REMARKS

Claims 1-9 and 11-28 are currently active in this case. Claims 1-4, 6, 8, 14-17, 20, 22-24, and 26-28 and the specification have been amended, Figures 1 and 2 have been corrected, and Figures 6A, 6B, 6C, and 7 have been added by way of the present amendment. All amendments, corrections, and additions are supported by the specification as originally submitted and no new matter has been added.

In the Drawings:

Fig 1:

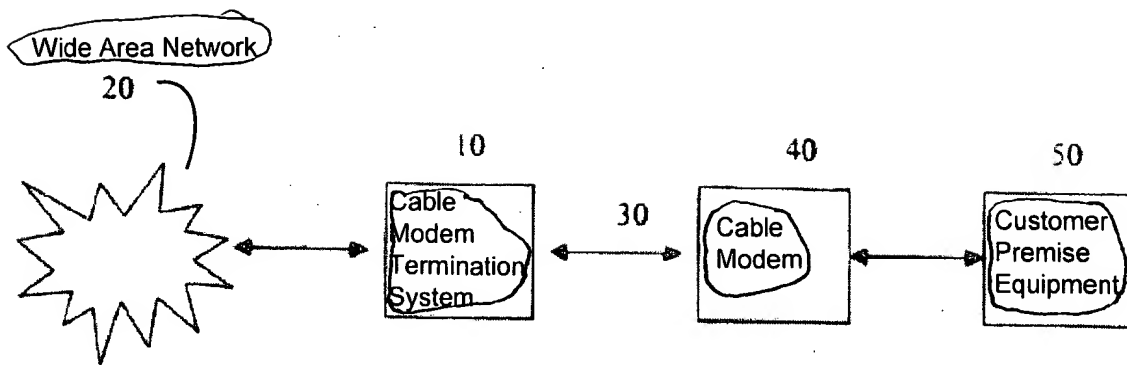
Applicants have added a Prior Art label to Fig. 1 as suggested by the Examiner in the outstanding Office Action.

Applicants have corrected Figs. 1 and 2 to include block descriptions.

The attached sheets of drawings include changes to Figs. 1 and 2, which replace the original Figs. 1 and 2, and which add descriptions to each of the blocks. Accompanying the Replacement Drawings are annotated marked-up drawings which show the changes made to the original drawings.

FIG. 2

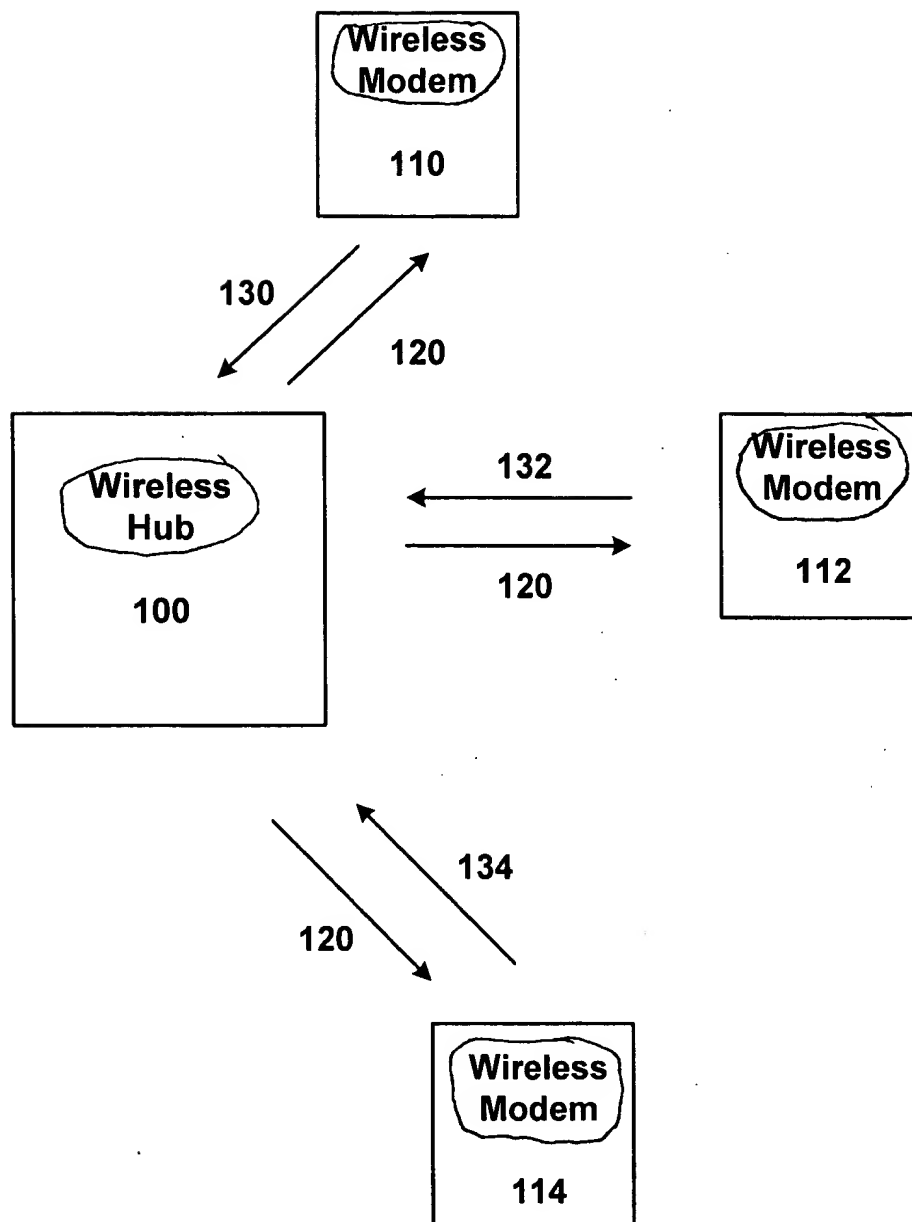
The specification has been amended to include the reference signs of Fig. 2
